PRCTI20230388

EGRESS ANALYSIS: Abatix

DRAWINGS PREPARED FOR
Abatix
410 Valley Ave NW Suite 102
Puyallup WA 98371
Pallet Rack Egress Layout

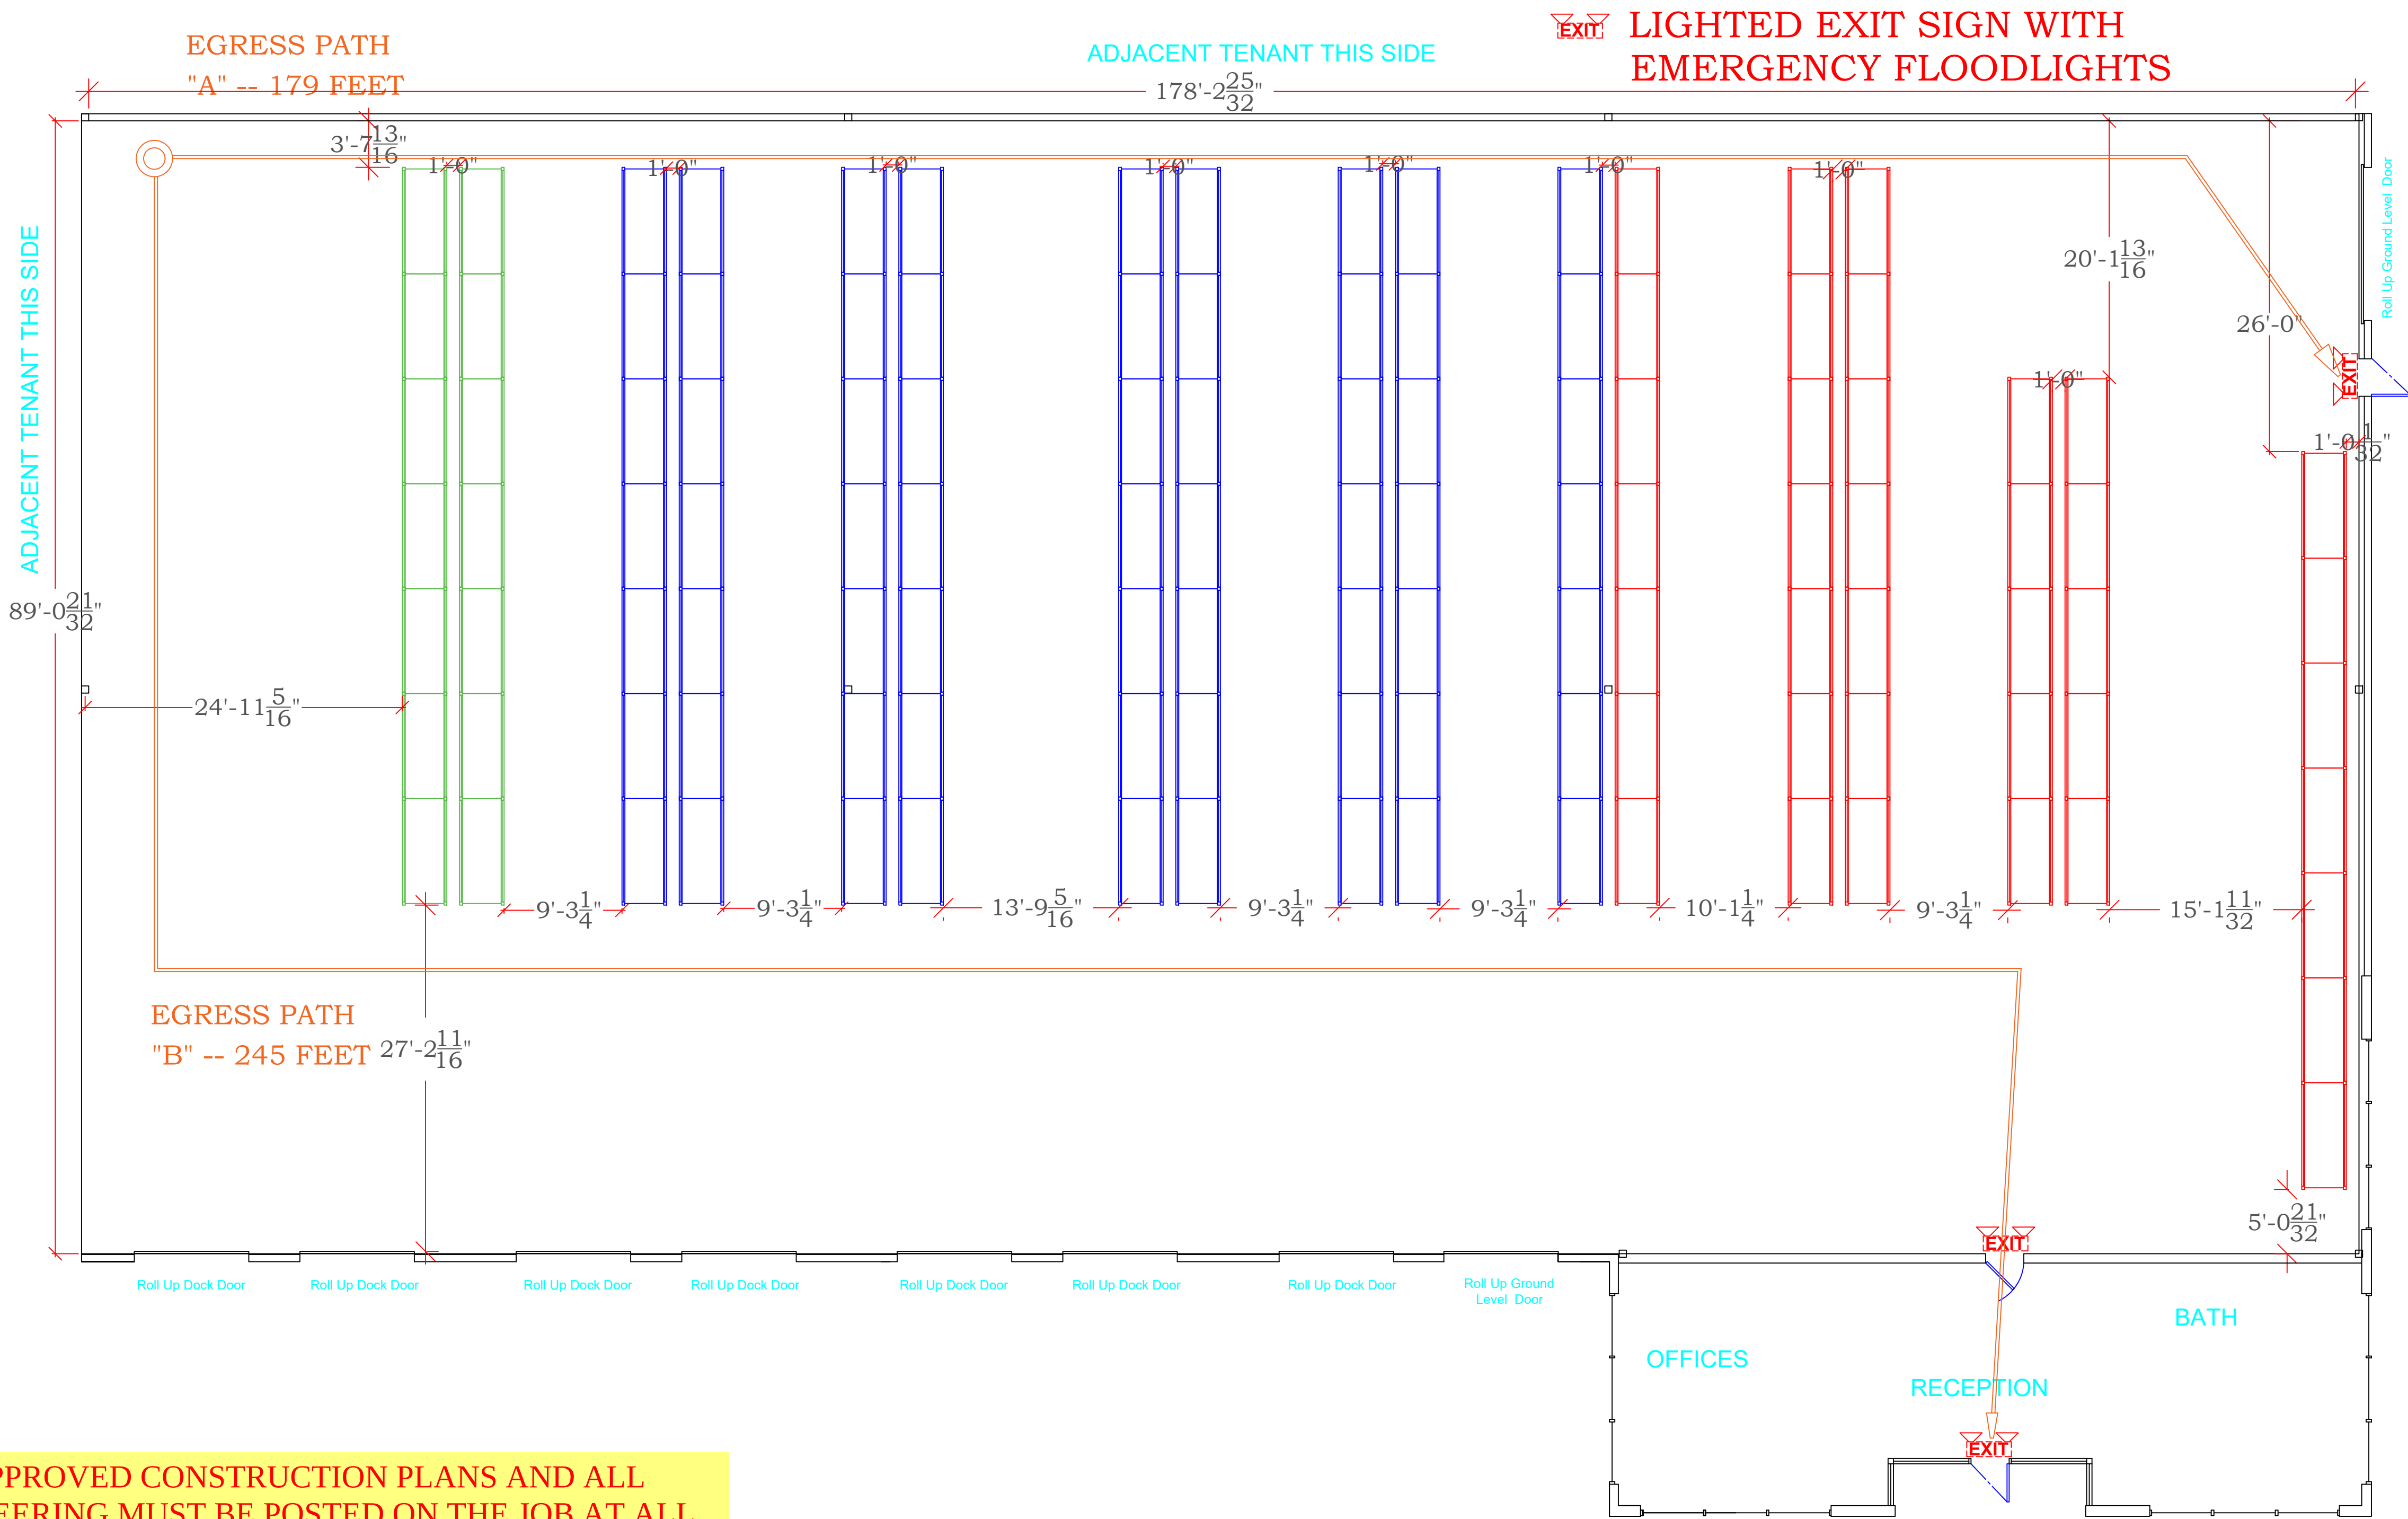
Add Exit Path Illumination as required by chapter 10 IBC

IBC SECTION1008
MEANS OF EGRESS ILLUMINATION
1008.1Means of egress illumination.

Illumination shall be provided in the means of egress in accordance with Section 1008.2. Under emergency power, means of egress illumination shall comply with Section 1008.3.

1013.1Exits and exit access doors shall be marked by an approved exit sign readily visible from any direction of egress travel. The path of egress travel to exits and within exits shall be marked by readily visible exit signs to clearly indicate the direction of egress travel in cases where the exit or the path of egress travel is not immediately visible to the occupants. Intervening means of egress doors within exits shall be marked by exit signs. Exit sign placement shall be such that no point in an exit access corridor or exit passageway is more than 100 feet (30 480 mm) or the listed viewing distance for the sign, whichever is less, from the nearest visible exit sign.
